RE: State Project No. 97870-3300
Fin. Project No. 251873-1-52-01
Contract No. 19,967
Dade County
State Road 821 (HEFT)
From Quail Roost Drive to SR 874

Subject: Alternate Traffic Control Dispute

DISPUTE REVIEW BOARD DECISION

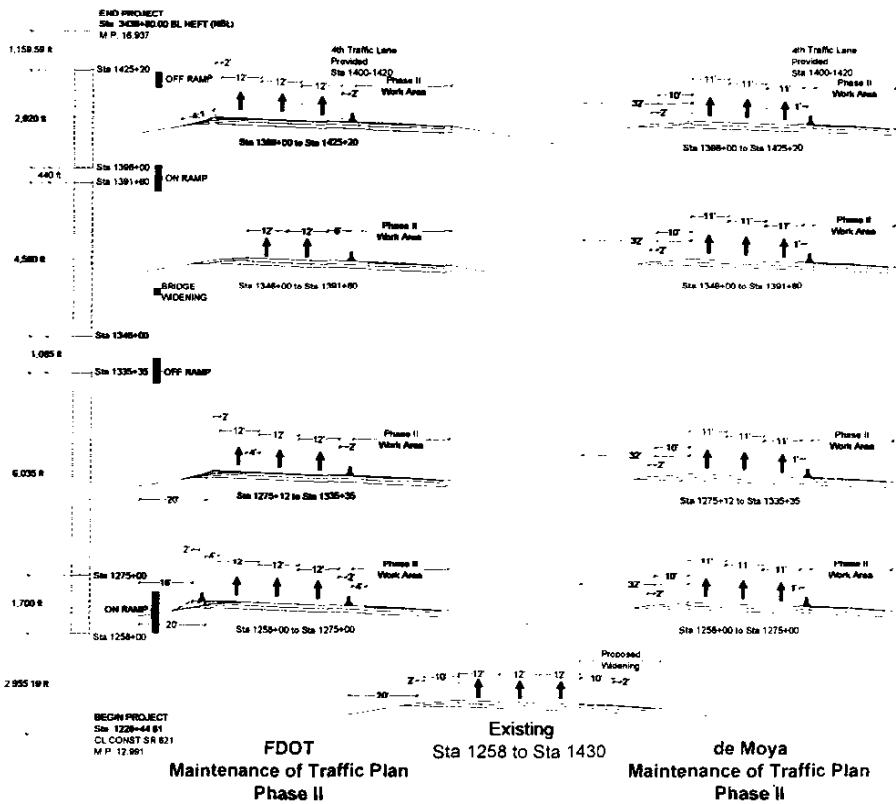
The dMG **Interim TCP** meets the requirements of the RPPM? Is the Interim TCP an enhancement to the FDOT Plan TCP?

In response to the Department's rejection of the conceptual dMG Alternate TCP, dMG provided the Department the dMG Interim RCP. On April 28, 1998, signed and sealed plans were provided by the de Moya Group. The Interim TCP maintained all existing traffic patterns and further exceeded the various enhancements that the Department requested.

- Three 12' Lanes
- 4' Barrier Wall Offset
- 6' Deflection Distance
- 12' Full Width Median Shoulder

The Department refused to pay for the barrier wall placement even though it was serving its intended purpose. As a result of the de Moya Group's efforts, the project proceeded under the dMG Interim TCP without delay.

- That the Interim TCP appears to be the most viable plan to keep the project on schedule. As long as this plan does not foreclose the implementation of the subsequent approved TCP plan and upon DMG addressing the Department's concerns as to completeness and approvability of the plan, that the plan be implemented. The initial placement of the Barrier Wall should be paid in accordance with the Contract. Subsequent relocation of this same Barrier Wall to the permanent position should not be eligible for payment.
